PROJECT MANUAL

*Building Decontamination
and Soil Remediation*
318 Urban Street
Buffalo, New York 14211

March 15, 1997

General Electric Company
One River Road
Schenectady, New York 12345

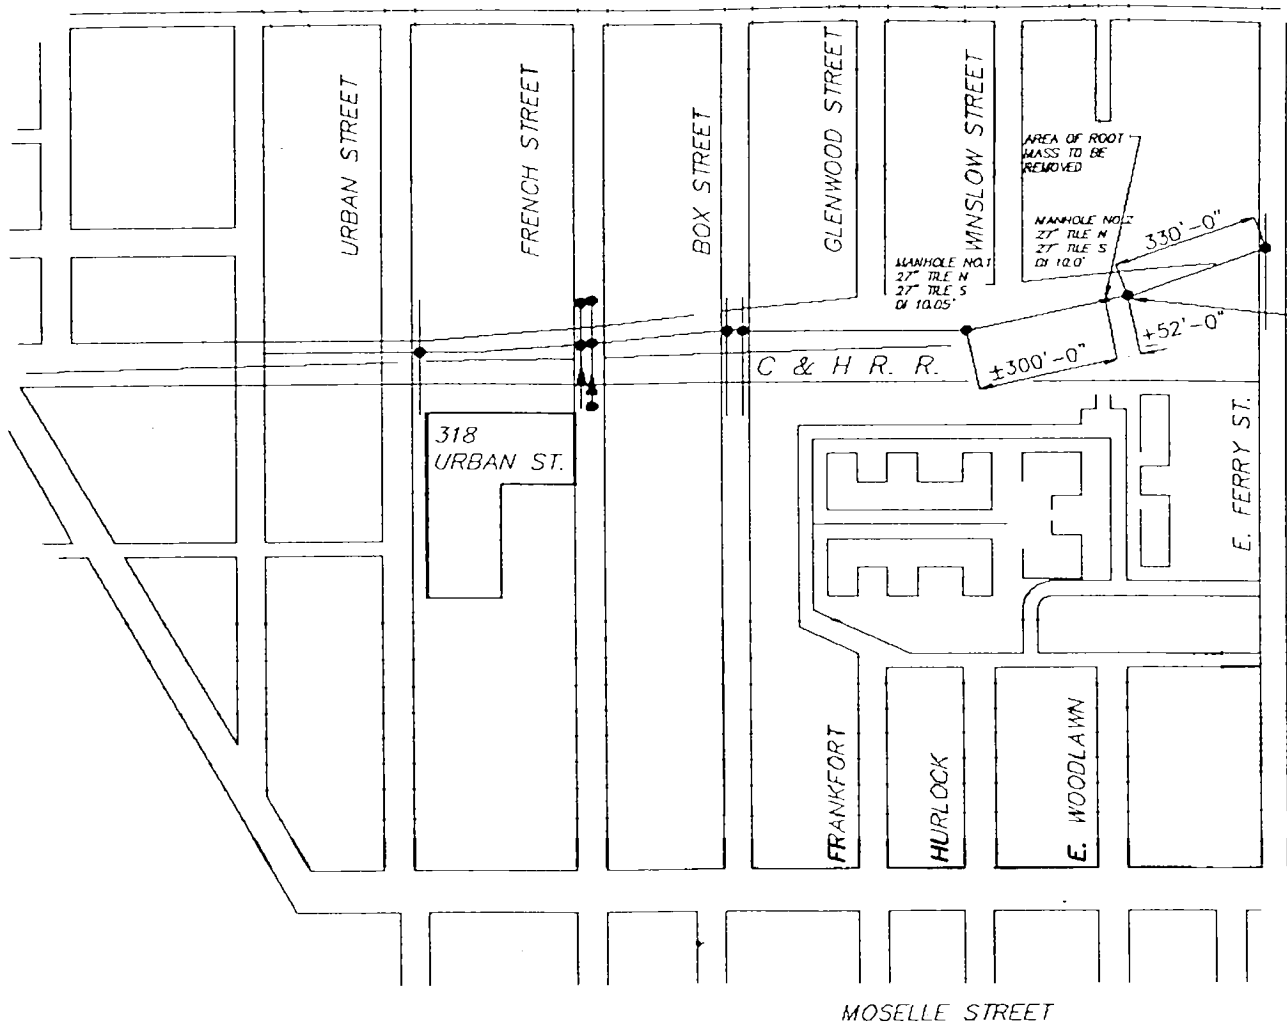
Drawing C-5

Delete detail # 8 in its entirety.

Drawing C-5 - Notes for Glass Block have been revised.

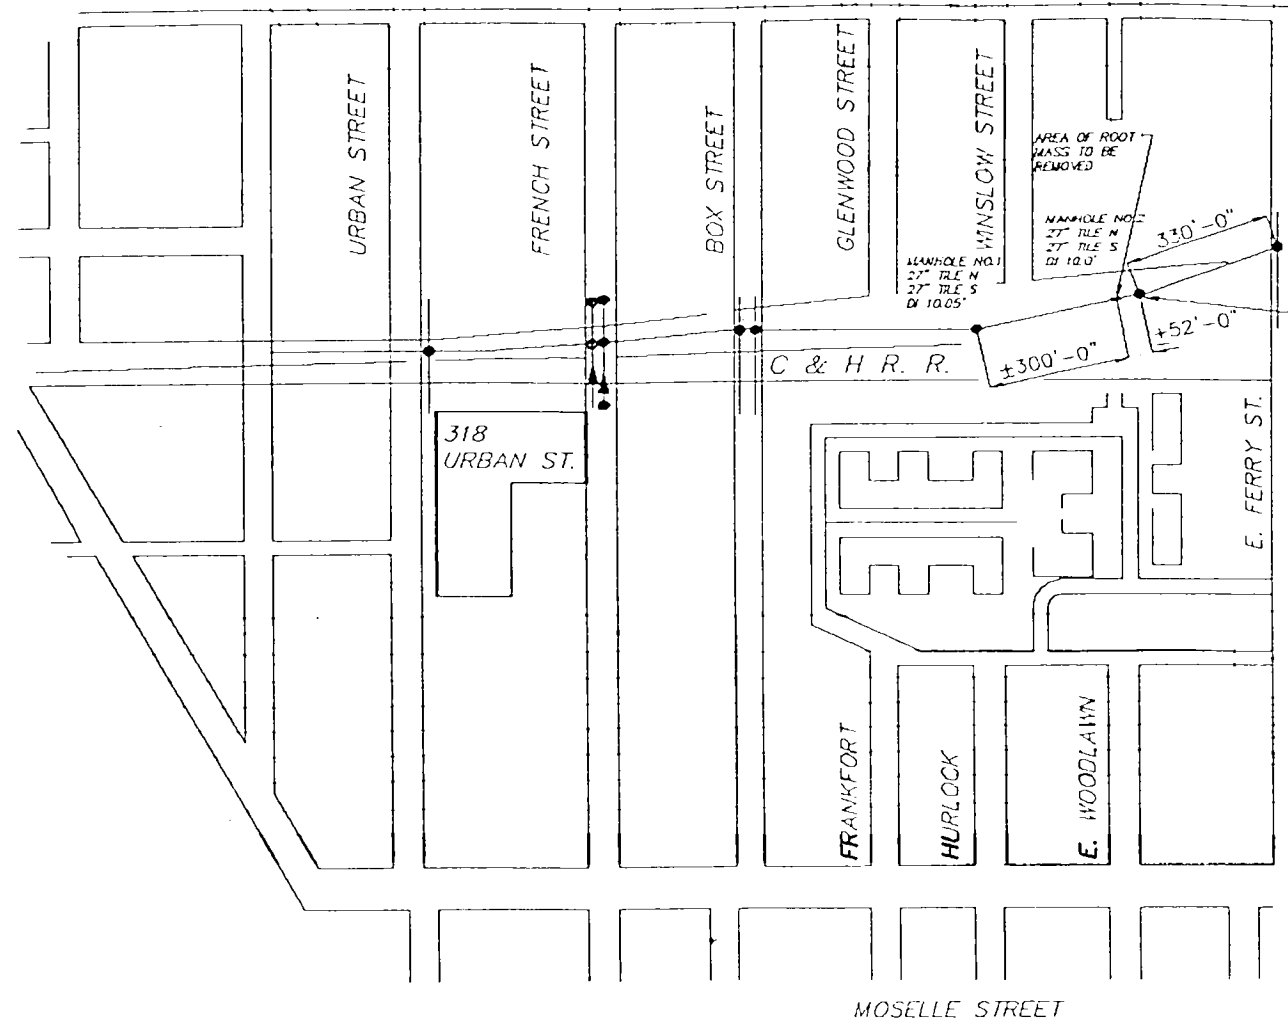
This Addendum No. 4 consists of information provided to ERM by Sweeney Steel on April 14 and 15, 1997. The following information is for bid purposes only, all bidders shall assume the scope of the floor replacement shall incorporate the following:

1. Clarifications in response to Bidder's questions raised since April 10, 1997.
2. Actual revisions to Attachment C, of Addendum No. 1.

Reinforcement in the areas having 4-inches of concrete is to be number 4 gauge, 4-inch by 4-inch on center wire mesh.

Concrete shall be a design mix with a minimum of 3,500 psi strength at 28 days.
